**ADDENDUM - 01**  
**REPAIR & REFURBISHMENT OF MPCB OFFICE AT TARAPUR, BOISAR. :**  
**INTERIOR AND ALLIED SERVICES.**

**Tender No.:- MPCB/EE/e-Tender-03/2020-21**  
**Tender ID:- 2021\_MPCB\_651519\_1**

**Maharashtra Pollution Control Board**

Pre Bid Meeting for E tender no **MPCB/EE/e-Tender-03/2020-21** held on 25<sup>th</sup> February 2021 at MPCB office, 4<sup>th</sup> Floor, Kalpataru Point, Sion Circle Sion East, Mumbai.

<b>FURNITURE LAYOUT</b>	
COMPREHENSIVE CONSULTANCY <small>Email: teamarkdesigns@gmail.com Tel. No., 022 24449817, 24303535</small>	
JOB NO. M/01/2013	REVISION NO.
DRAWING NO. MPCB/TARAP /TEN/INT/FURN	01

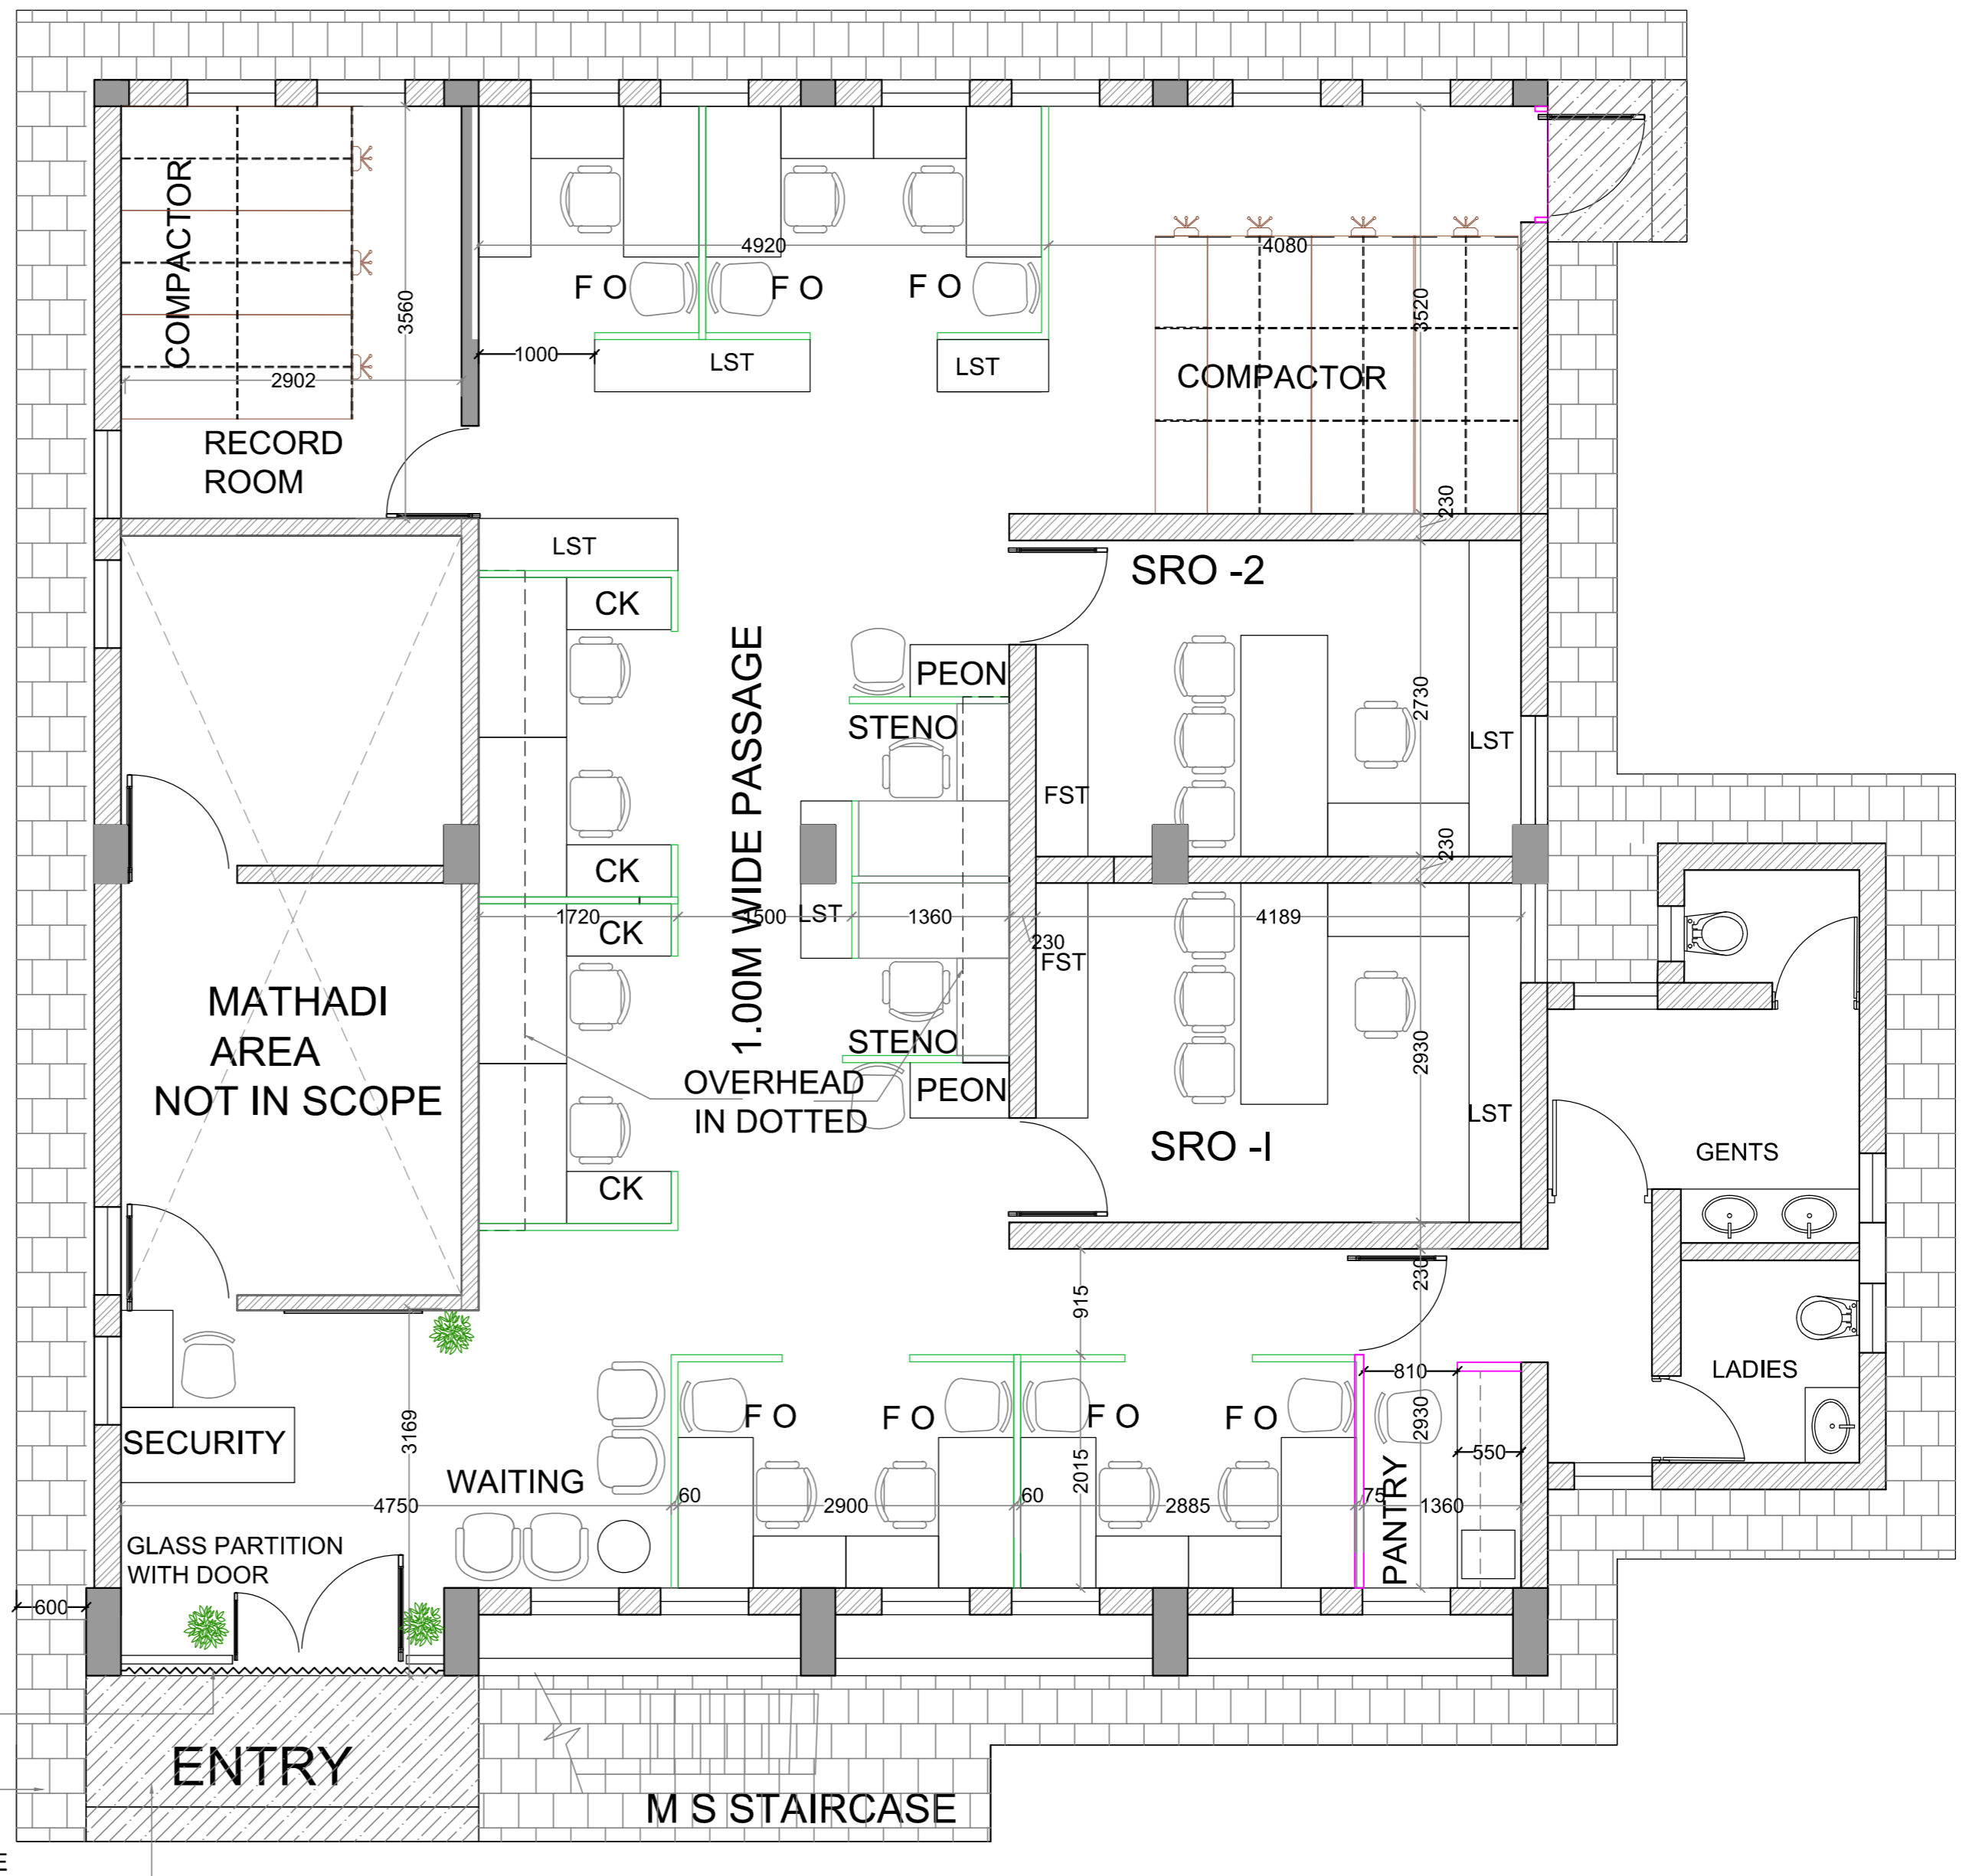
Sr. No	Description	As per Tender	Addendum / Reply
1	Drawing is not enclosed with the tender document. Please issue the Tender Drawing.		Drawing Attached.
2	Item no. 1.07 if of Removing the Existing Furniture, Storage Units Etc. and in Item no. 1.08 its of Repositioning of all Furniture & Storages. So are these two item related to each other?	Item No. 1.07 - Removing of all furniture's /storage units such as tables, chairs, cupboard etc and stacking the serviceable materials as directed and disposing of unserviceable materials with all leads and lifts etc. complete.  Item No. 1.08 - Repositioning of all furniture's/storage units such as tables, chairs, cupboard etc as directed with all leads and lifts etc. complete.	Both are different items.
3	Item no 5.06 of Vitrified Tiles. The unit of item given is in Number. Please clarify?	Providing and laying vitrified stone effect finish tiles having size 590 to 605 mm x 590 to 605 mm of 8 to 10 mm thickness and confirming to IS. 15622-2006 (Group Bla) of approved make, shade and pattern for flooring in required position laid on a bed of 1:4 cement mortar including required position laid on a bed of 1:4 cement mortar including neat cement float, filling joints with epoxy grouting, spacers,, curing and cleaning etc. complete. a) flooring b) Skirting	Item to be considered in Sq. mtrs.
